TO: City Plan Board

DATE: June 23, 2016

SUBJECT: Petition PB-16-50 SUP: Boos Development Group/CHW, agent for Jeff Montgomery Associates, LLC, owner. Special use permit with development plan review for construction of a new commercial development with drive through. Zoned: MU-1 (8-30 units/acre mixed use low intensity). Located at 4322 NW 53rd Avenue.

FL PE No. 58206
 SHEET NO. C1.00

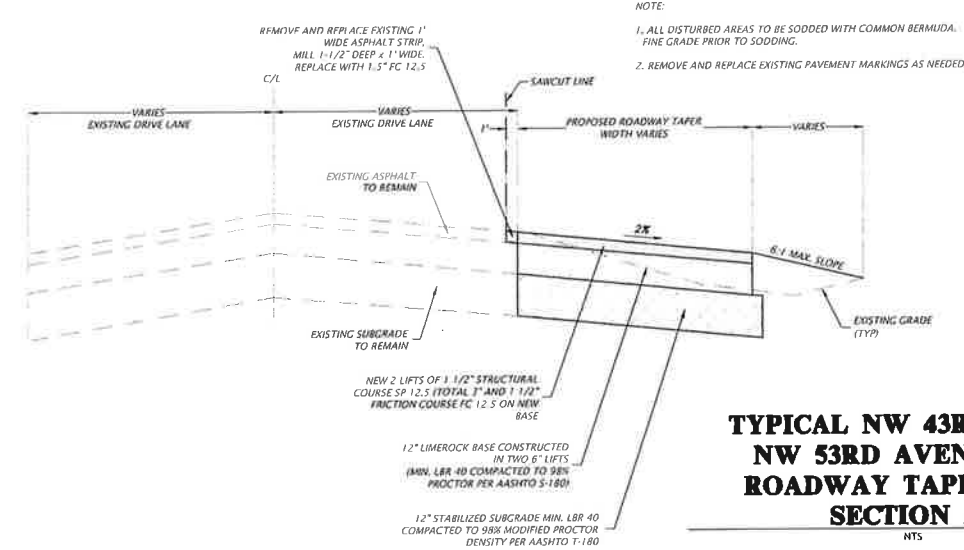
- **Limit of single family property boundary has been added. See Sheet C1.00.**
4. Please show the setback limits for development adjacent to a residential district.

1. Typical asphalt design could not be located.
 - **See Sheet C0.12 for detail.**
2. The western elevation of the proposed bank appears to show an awning that based upon rough scaling appears to possibly encroach into the drive thru lane. Please verify horizontal and vertical clearance requirements are met.

- **Overhang and doors have been added to the plans and are not in conflict. See Sheet C1.00.**
3. The floor plan for the bank shows a door on the western side and egress. Based upon scaling it appears the door will encroach into the drive thru lane. Please verify egress and clearance requirements are met.

- **Setback limit is shown on Sheet C1.00.**
5. The proposed traffic activities at the SW corner of the site is within close proximity to the closest single-family dwelling to the west; please demonstrate how those potential impacts will be addressed. Compatibility issues must be addressed in the Special Use Permit; it appears that a hospital would generate additional emergency activities which may have impacts on the adjacent residential area.

- **Overhang and doors have been added to the plans and are not in conflict. See Sheet C1.00.**
4. What is the anticipated traffic pattern for the drop off area / front door for the emergency? Vehicles depicted would seem to be entering / exiting in the wrong direction based upon parking lot aisle layout and typical passenger unloading.

FL PE No. 58206
SHEET NO. C2.00

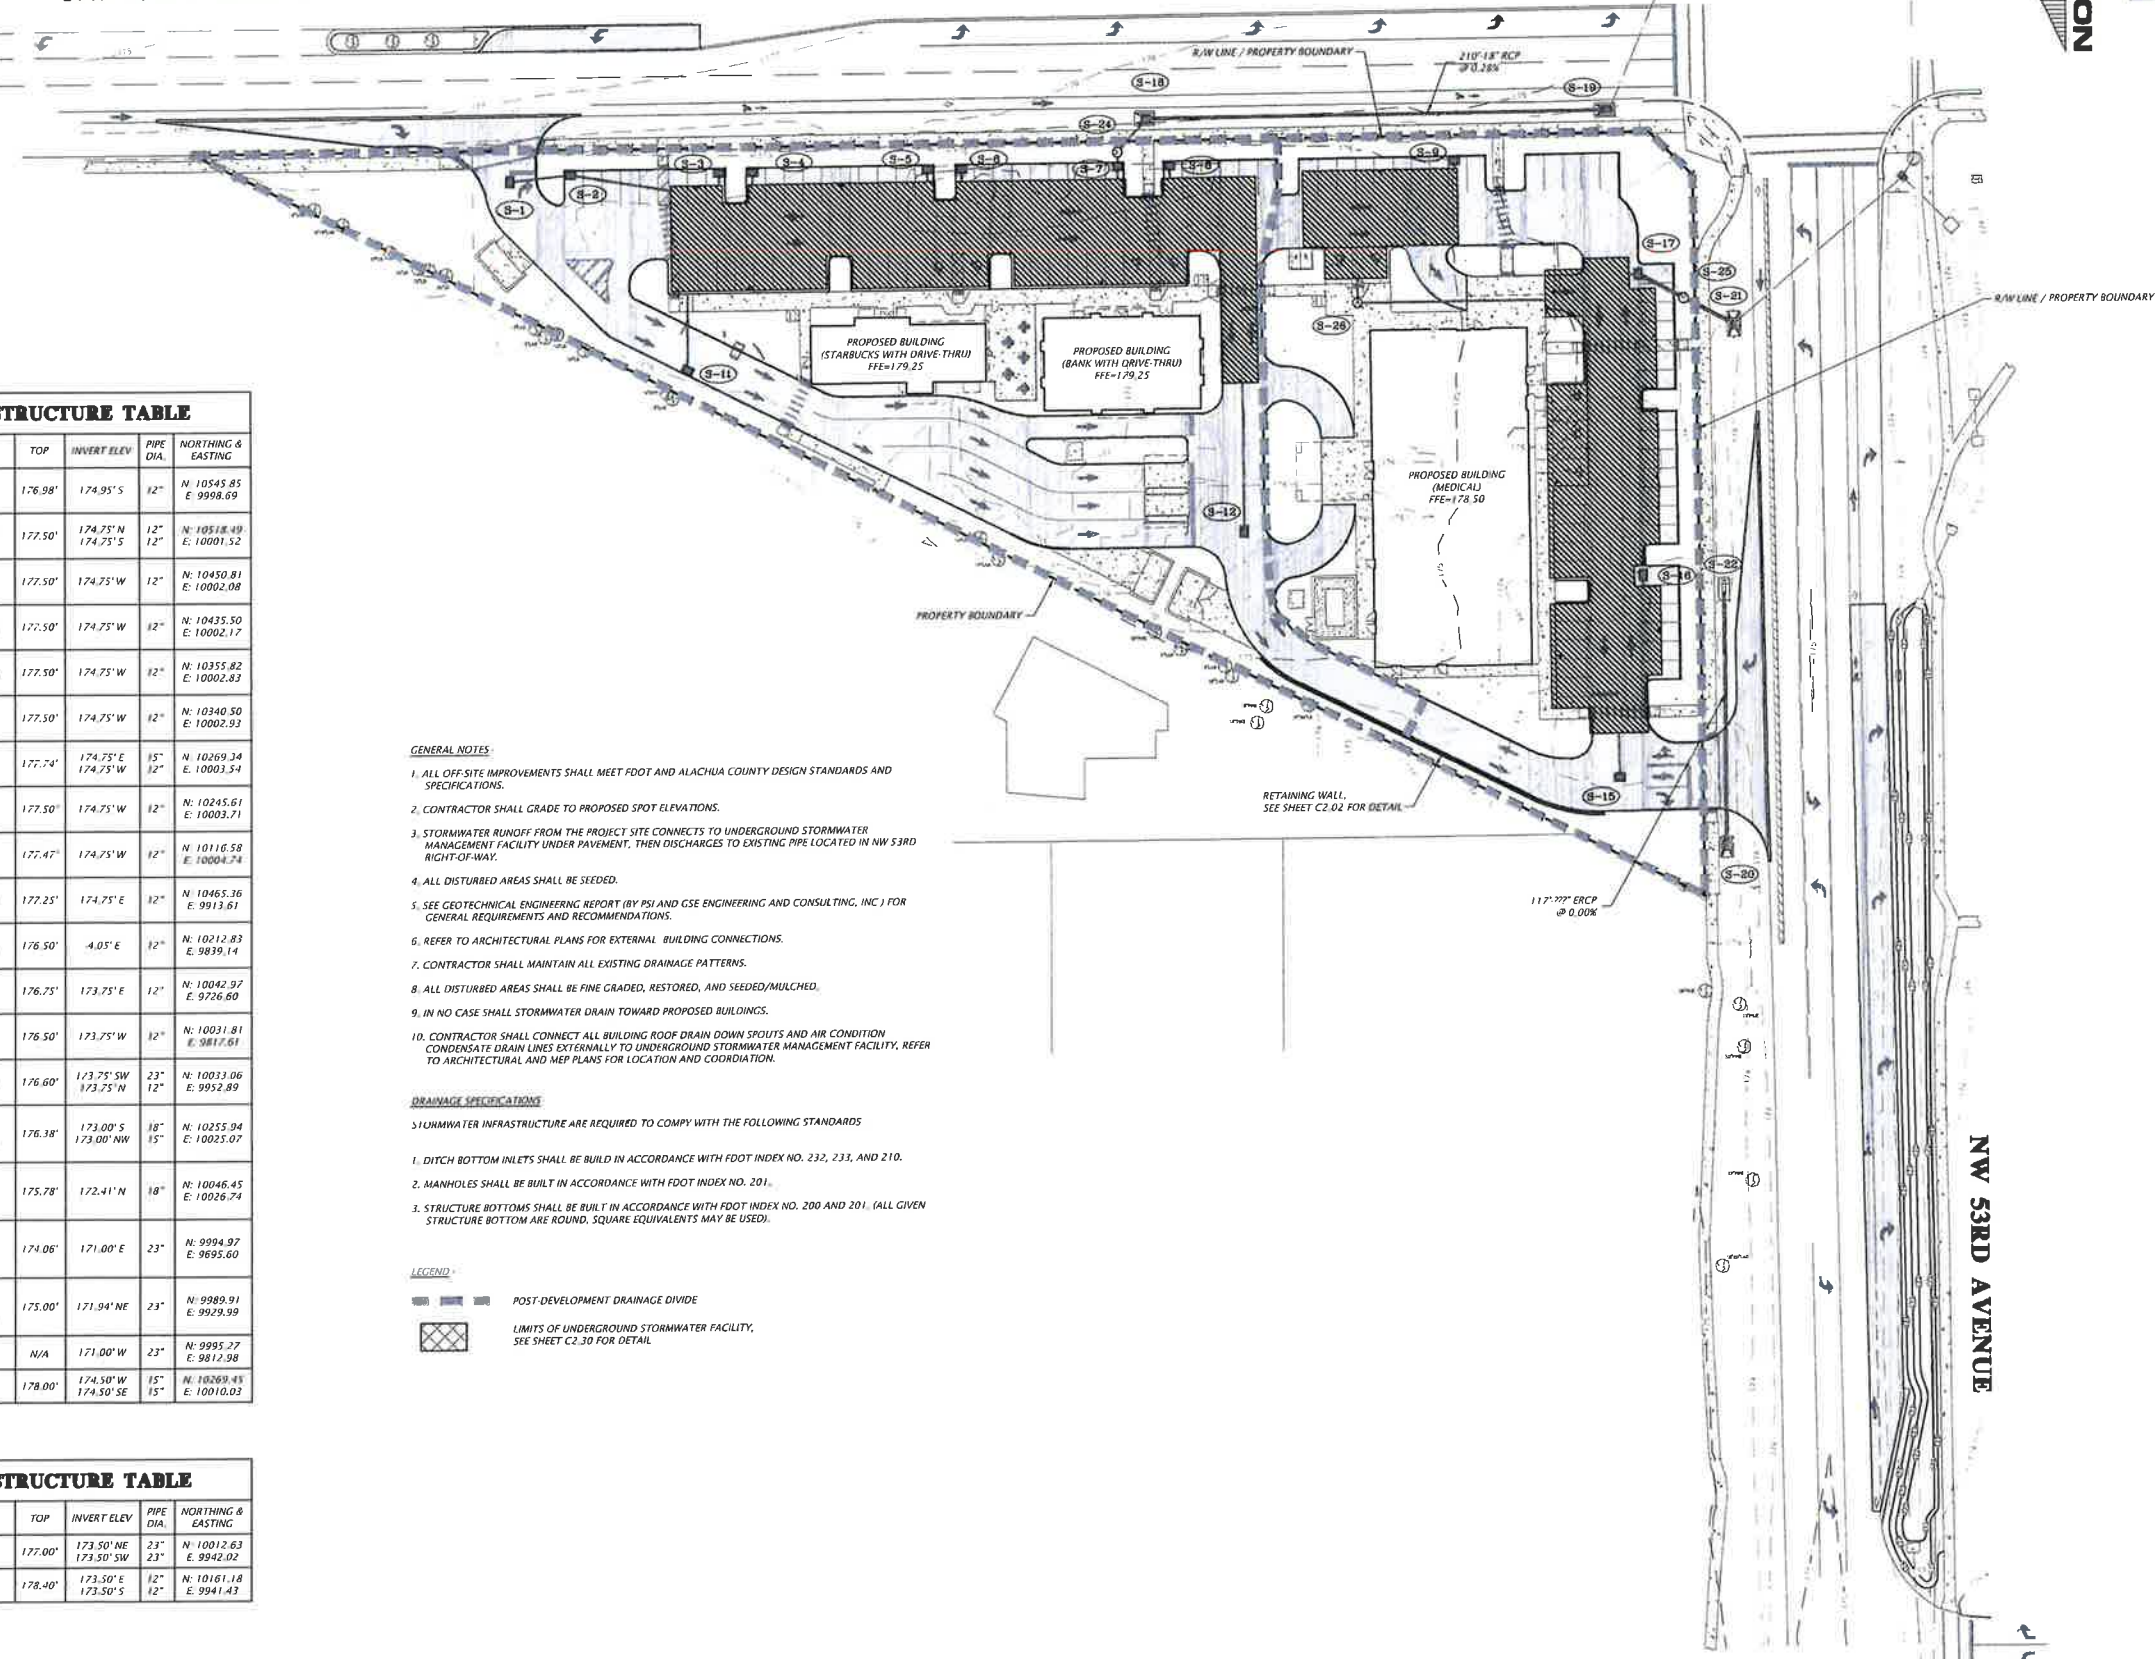
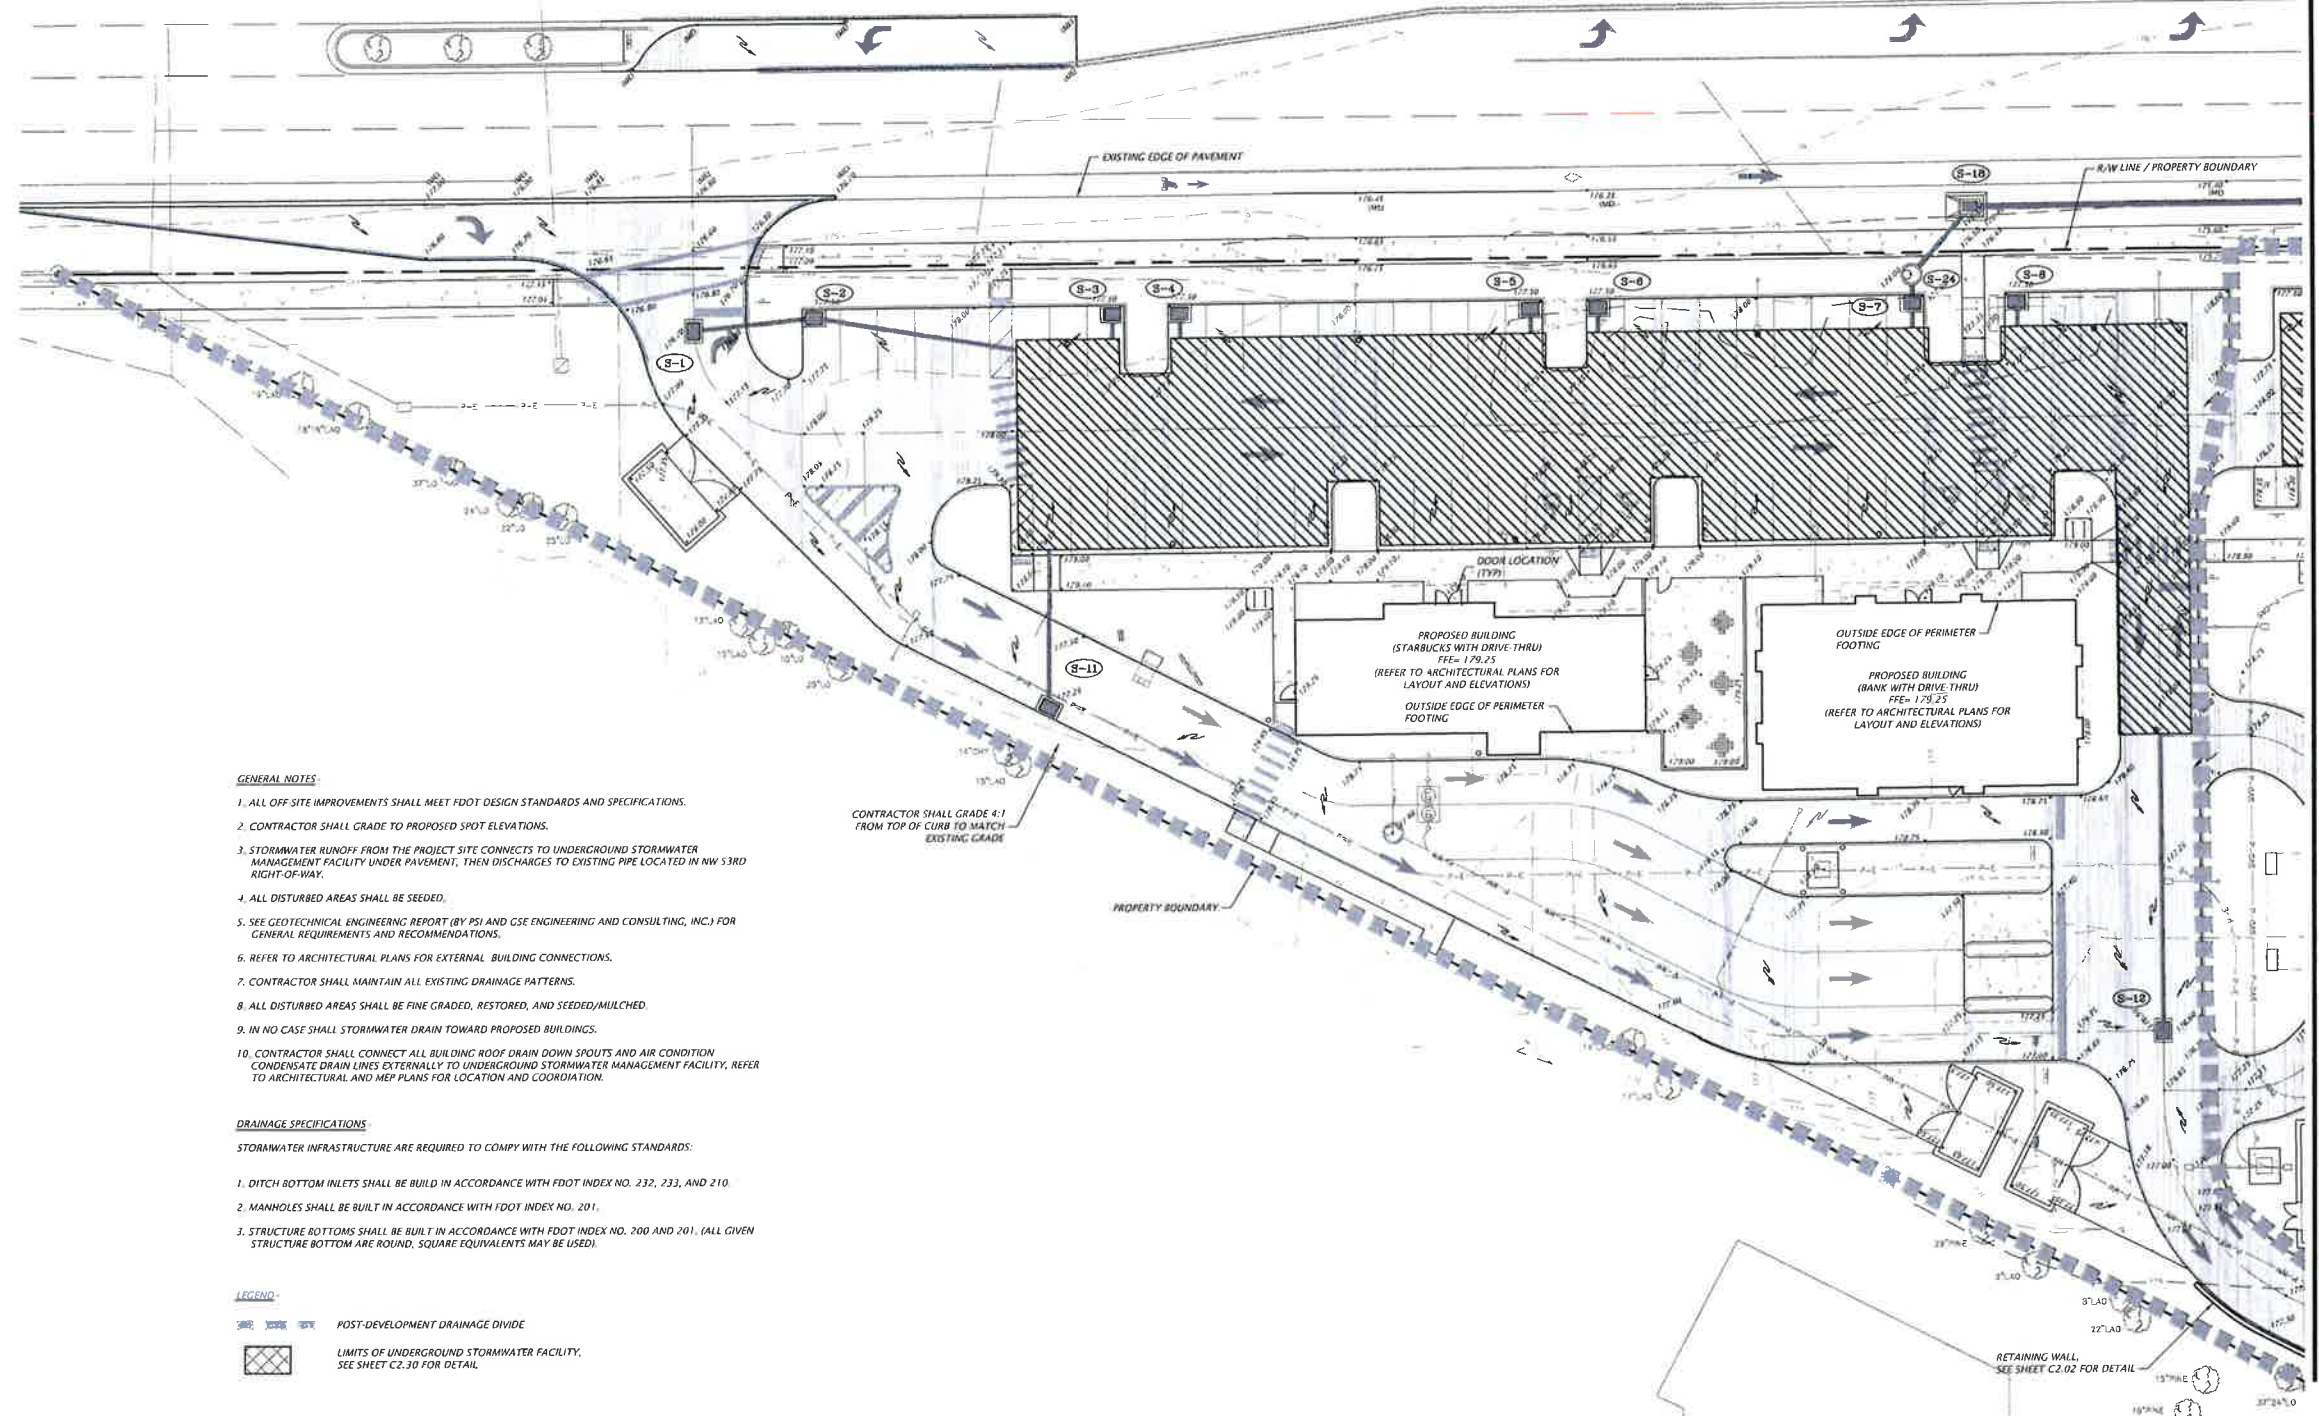
1 - For SMF-1, it appears the structure S-1 would be the lowest inlet top associated with this facility. Currently, the calculations show that .09 feet of freeboard is provided within the stormwater facility. The additional storage can be provided in the proposed parking lot, but S-1 would drain directly into the right-of-way.

1. Where does the stormwater collected from inlets S-1 and S-2 being treated?
 - **Storm network has been revised and collection is provided. See Sheets C2.00, C2.01, C2.02, and C2.30.**
2. The post-developed discharge rate exceeds that of the pre-developed amount for the 100 year, 2 hour and 100 year, 4 hour storm events.
 - **Cumulative post-developed discharge rates are now below the pre-developed rates.**
